RE: TEDS Exception No. 14-03, from Minimum Parking Module Width in Proposed Garage at 722 Belford Avenue

DESIGN EXCEPTION #DE14-03

Exception from Minimum Parking Module Width in Proposed Garage

Re: Request For TEDS Exemption for Parking Garage Parking Stall Dimensions

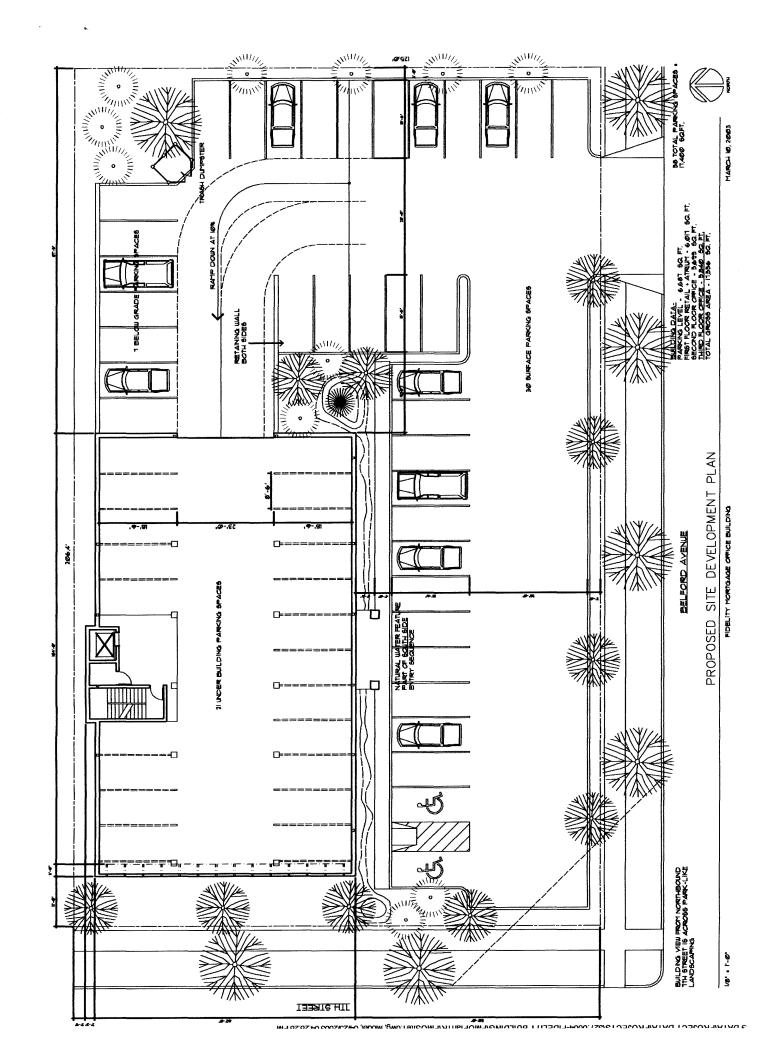
An exemption from this requirement is being requested for a new underground parking garage that is proposed to be constructed under a new office building proposed at 722 Belford Avenue. Our project proposes to provide 8.5-ft wide by18.5ft deep parking spaces with a 23-ft isle width, which are industry standard layout dimensions for a majority of enclosed or underground parking structures. The TEDS minimum requirements are 8.5-ft wide by 18.5-ft long with a 28-ft isle width. The City of Grand Junction's Two Rivers Plaza enclosed parking area has 18-ft parking stall depths and a 19-ft isle width. These narrower dimensions are needed to minimize structural span requirements for these facilities.

I have included an exhibit that depicts the parking garage layout requested by this exemption. If you have any additional question or concerns, please give me a call at 242-7540.

I recommend approval of the necessary Design Exceptions to Section 4.3.2.1 to allow the proposed narrower parking modules for this parking garage.
